Ref: YBF York Station

York Bus Forum Proposals for York Station Frontage

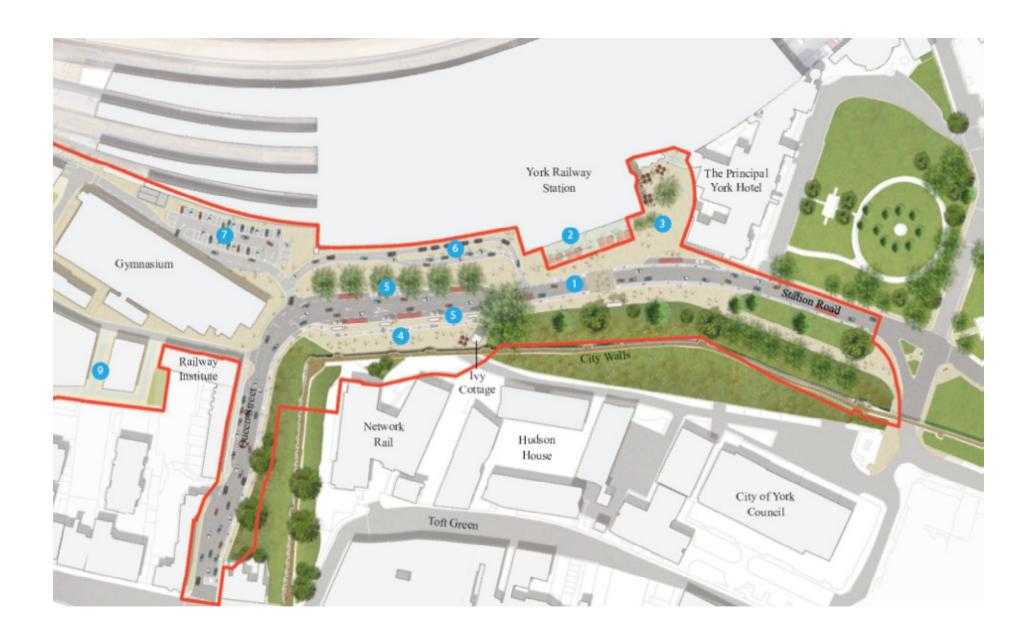
The current CYC proposal is shown in figure 1. As can be seen, it features:

- A movement of the bus stopping area from being immediately in front of the portico to a location approximately 200m west of the portico
- A replacement of the current 8 on-road stops with 10 on-road stops (eight of which are within super-stops (ie space for two buses to stop but just one pole so there are six bus stop poles).
- Two layover bays on the circulation road adjacent to the Railway Institute to accommodate terminating buses during drivers' rest breaks (there is no facility for this at present)

- A bus stop and layby on the access road adjacent to the entrance to the proposed short stay car park to accommodate services which would turn at York Rail Station, but which do not lay over there (such as the existing service 66). Like the layover bays, this is an entirely new provision.

- There is no change to the location of the Tour Bus stop near to Tea Room Square, although the new stop is somewhat longer than the existing stop.
- It is also worth pointing out that the new bus stops will be provided to current design standards for bus stops (which the existing stops are not), so, for example, the length of the proposed lay-bys is 120m, replacing the current layby on the south side of Queen St (adj to the old tram shelter) which is 87m long. Further space is freed up by the replacement of articulated buses on two of the park and ride services to the Rail Station (3 and 7) with double decker buses, which are considerably shorter (although it is, of course, possible that articulated buses may return in the future).
